STATE OF VERMONT
AGENCY OF TRANSPORTATION

PROPOSED IMPROVEMENT
VILLAGE OF OLD BENNINGTON
COUNTY OF BENNINGTON
WALLOOMSAC RD.
(TH. 902, URBAN COLLECTOR)

RECORD PLANS

PROJECT OLD BENNINGTON
M 1400(4)S
SHEET 1 OF 63 SHEETS

FROM STA.	95+50	TO STA.	96+40
PROJECT NAME	OLD BENNINGTON MAIN		
NO.	M1400(4)S	PLOTTED	06/15/93
SURVEYED BY	MOREAU	01/90	0294
SHEET 40	OF 63 SHEETS

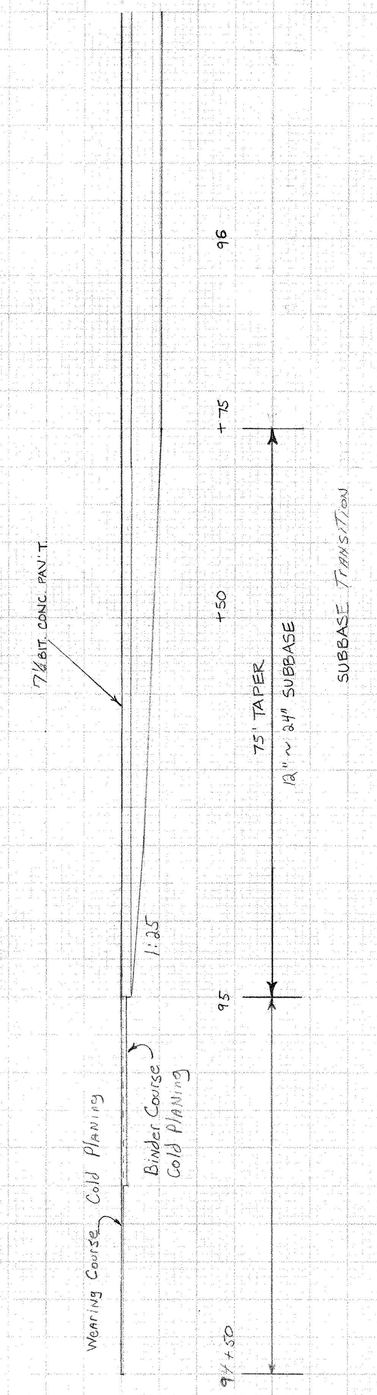
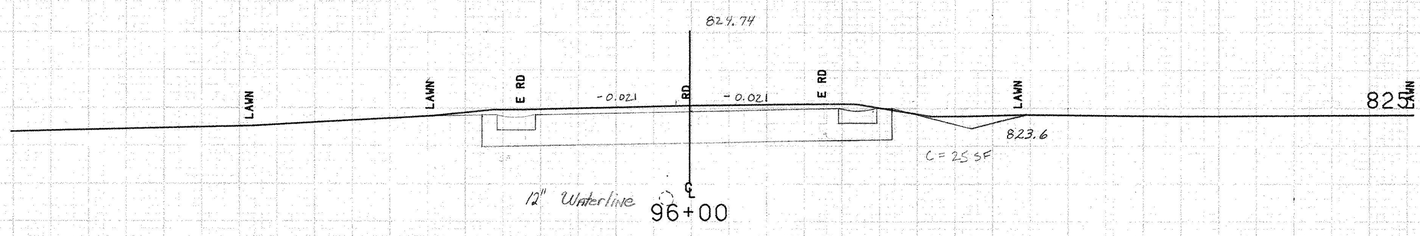
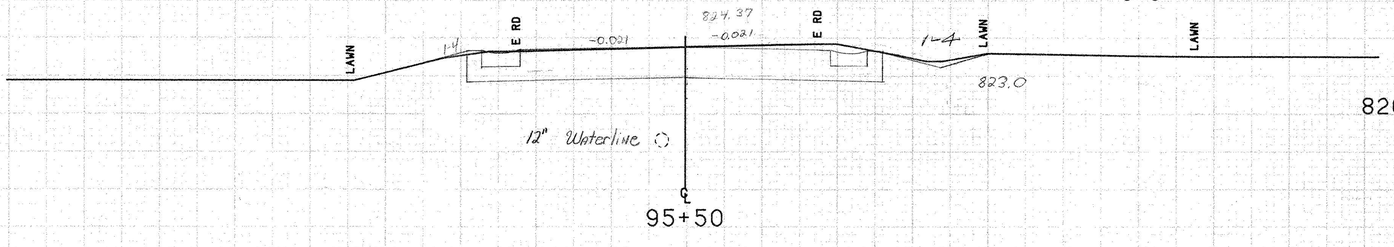
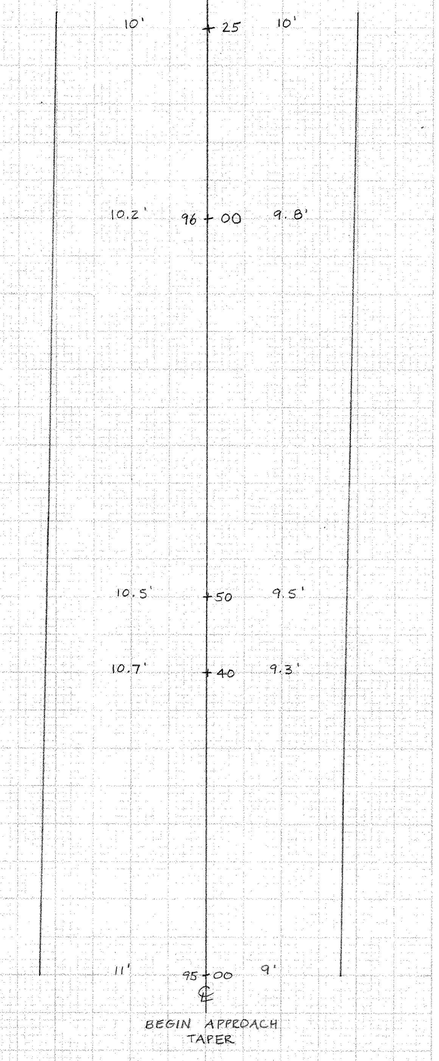
STA 96+20 RT ~ 96+55 RT
Granite Gutter is to be
Set in place with No
Swale across Drive.

FROM STA.	96+57	TO STA.	97+50
PROJECT NAME	OLD BENNINGTON MAIN		
NO.	M1400(4)S	PLOTTED	06/15/93
SURVEYED BY	MOREAU	01/90	0294
SHEET 41	OF 63 SHEETS

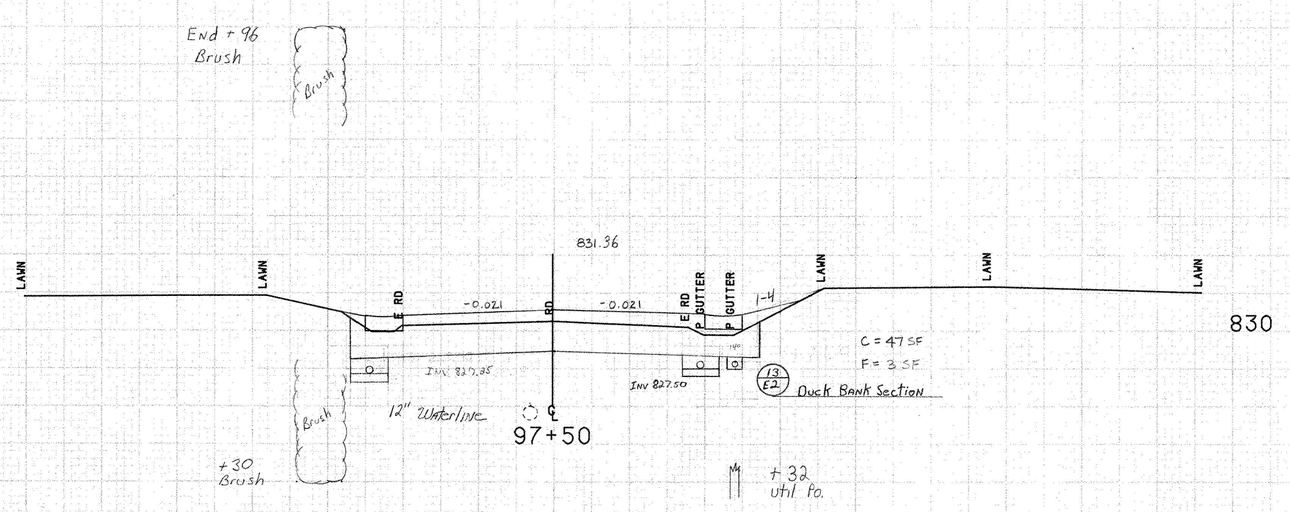
Note: Underdrain offset may be Adjusted As Needed to Avoid Conflict With Utilities As Approved by the Engineer.

Note: Bricks may be omitted from DI As Needed for Clearance Over Culvert.

FROM STA.	104+35	TO STA.	104+70
PROJECT NAME	OLD BENNINGTON		[redacted]
NO.	M1400(4)S		PLOTTED 02/24/86
SURVEYED BY	MOREAU		JAN. 1986
SHEET 52 OF 68 SHEETS

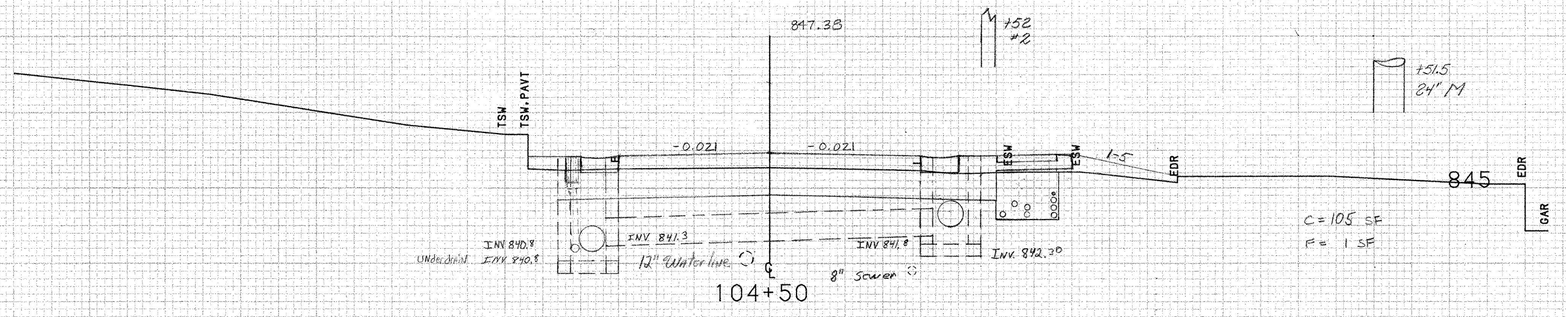
STA 104+57 RT.
Remove & Reset Marble Walk
As Directed by the Engineer
As Agreed to by the Property
Owner.
Payment Subsidiary to Common
Excavation.

FROM STA.	107+41.50	TO STA.	107+47.62
PROJECT NAME	OLD BENNINGTON		[redacted]
NO.	M1400(4)S		PLOTTED 02/24/86
SURVEYED BY	MOREAU		JAN. 1986
SHEET	38 OF 63	SHEETS

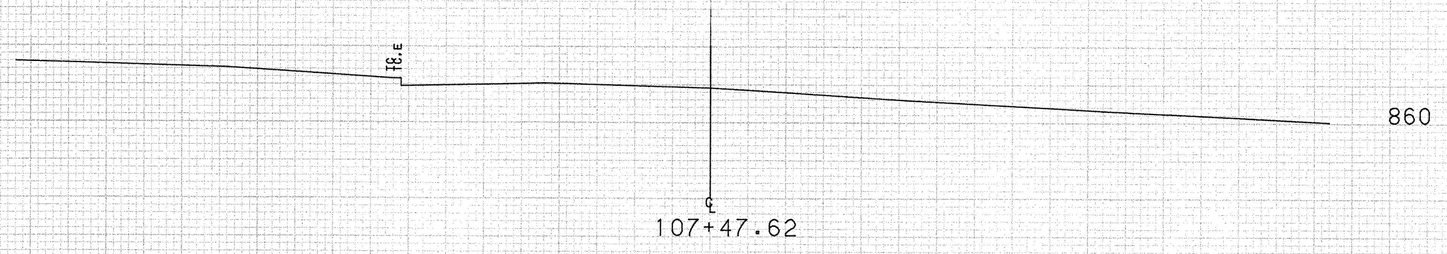
Match New Gutter & Sidewalk To Existing
@ 107+45 Rt. (Monument Ave.)
